Edinburgh Airport Airspace Change Programme 2019

Stage 1 communications outwith the CAP1616 process

EANAB's response to the Statement of Need - 10 to 19 April 2019

This is what flight path expansion looks like (1st ACP)

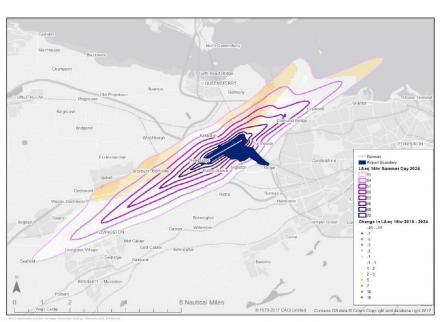
- There is no evidence of runway capacity issue in the data made available to us, therefore EANAB concludes that there is no runway capacity issue unlike it has been claimed in the SoN.

2. Focus on movement capacity instead of the more imminent departure capacity problem

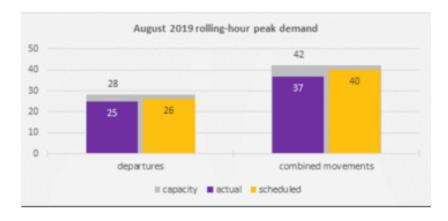
EANAB's focus is on total movement capacity – while this is something we are keeping an eye on, our more immediate concern is in **departure** capacity. For August 2019:

- Peak rolling-hour departure was 25 compared to capacity of 28: we had a resilience buffer of 3aircraft
- Peak rolling-hour movement was 37 compared to capacity of 42: we had a resilience buffer of 5 aircraft

Figure 2 - Three routes concentrated in the vicinity of Dalgety Bay (Base map from EAL consultation 2)

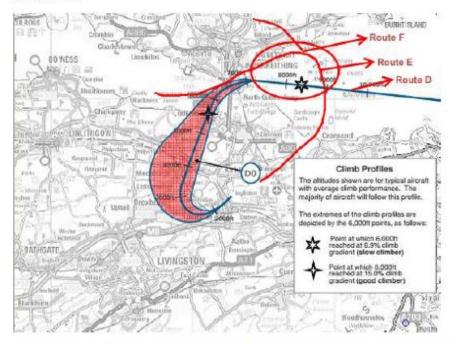
It was previously stated that the proposed route D from the previous ACP would have no impact on Dalgety Bay. However, the centreline of the proposed route D was only around 1 mile from the town and any deviation off the centreline would have seen aircraft directly over the town. It was also stated that flights would be 7-8,000 feet whilst 'passing' Dalgety Bay, however this was based on an assumption that aircraft would be at 2,000 feet around the Newbridge Roundabout during take-off and, in fact, any aircraft climbing slower than average would result in flight heights far lower than 7,000 feet at Dalgety Bay. Figure 2 below shows that under the last ACP three routes, D, E and F, were to be concentrated over one small area, leading to high levels of aircraft noise no matter whether the wind direction was east or west. It was decided to pursue routes with the tightest possible turns over the Dalgety Bay area from either direction. The Forth is too narrow at this point to provide sufficient distance from centres of population to protect them from the negative impacts of aircraft noise and the wider part of the Estuary should be used.

Figure 3 - Alternatives considered by EAL during their ACP (Source EAL consultation 2)

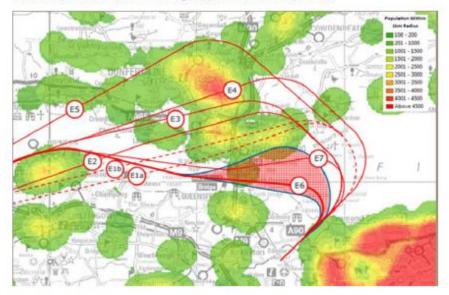
As can be seen from the options map below (Figure 3), the options of flying further east up the Forth (until at least 7,000 feet) before turning back west or using far less densely populated areas (as shown white on the map), were not considered as part of the last ACP. Routing E7a over Dalgety Bay and surrounds did not in any way minimise the population overflown, and it would be difficult to fly over a more densely populated area at this height, other than a sharp right turn flying over Edinburgh. It is not the case that, as there is an existing route, the impact of any new route(s) is not significant. As traffic numbers are set to grow greatly, Dalgety Bay is far larger than it was in the 1970s, there are cumulative effects of various routes and there are many alternative options, flying over Dalgety Bay cannot be considered the most sustainable long-term option and should not be considered an option in any ACP. Impacts on areas of high population density under 7,000 feet should be avoided, particularly where an
